ITEM NO <u>120030</u> MEETING DATE <u>2-13-2013</u> STAFF <u>HOLLAND</u>

STAFF REPORT

- **PROJECT:**BDR Four Unit Multi-Family
621 South Meldrum Street
Project Development Plan #120030
- APPLICANT: Cathy Mathis The Birdsall Group 444 Mountain Avenue Berthoud, CO 80513
- OWNER: Big Deal Real Estate, LLC Jeff Eggleston 2519 Ridge Creek Road Fort Collins, CO 80528

Site Plan

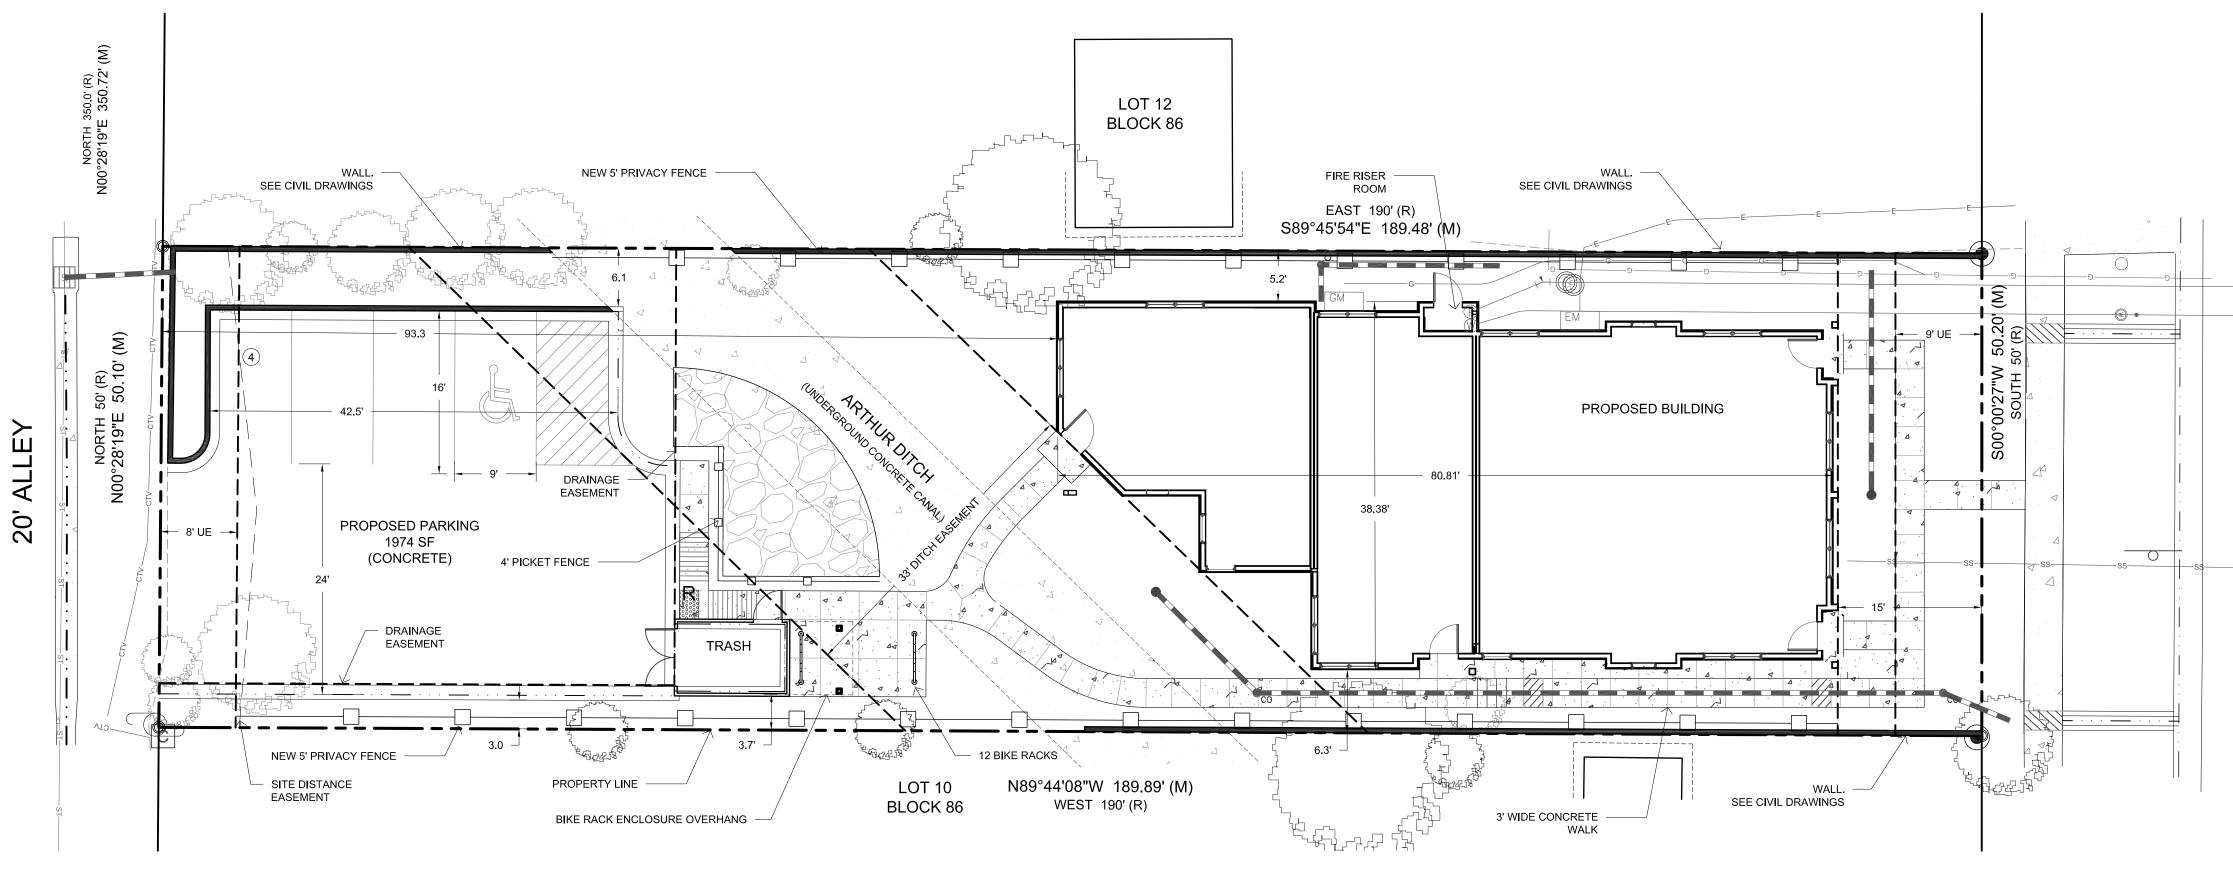
The applicant proposes a Modification of Standard to Section 3.2.2(J) to permit a parking setback of 3 feet along the southern boundary of the parking area.

• The intent of the required 5' vehicle use area setback is to provide sufficient space for visual screening and to enhance the appearance of the vehicle use area. The 3' of landscape area, in combination with the privacy fence, provides a softened landscape edge interior to the parking area while mitigating the visual impact to the property to the south. Additionally, the 2' reduction is proposed along the parking drive isle, and not directly adjacent to the parking spaces, where the impact of a reduced setback would be greater.

- The 2' reduction is proposed along the parking drive isle, and not directly adjacent to the parking spaces, where the impact of a reduced setback would be greater;
- The setback as modified permits a parking area that would otherwise be infeasible while providing consistency with the LUC in terms of lot width, primary building setbacks, and with enhanced architecture that provides appropriate massing, scale, detail and articulation and;
- The parking setback as modified permits a development plan that accommodates off-street parking that would otherwise be infeasible. While parking spaces are not required of this project, the off-street spaces provided help reduce on-street parking demand, therefore providing a benefit to nearby neighbors without any significant adverse impacts.
- D. Section 3.5.1 Building and Project Compatibility

Staff recommends approval of the Modification. In evaluating the request, and in fulfillment of the requirements of Section 2.8.2(H)(1) Staff makes the following findings of fact:
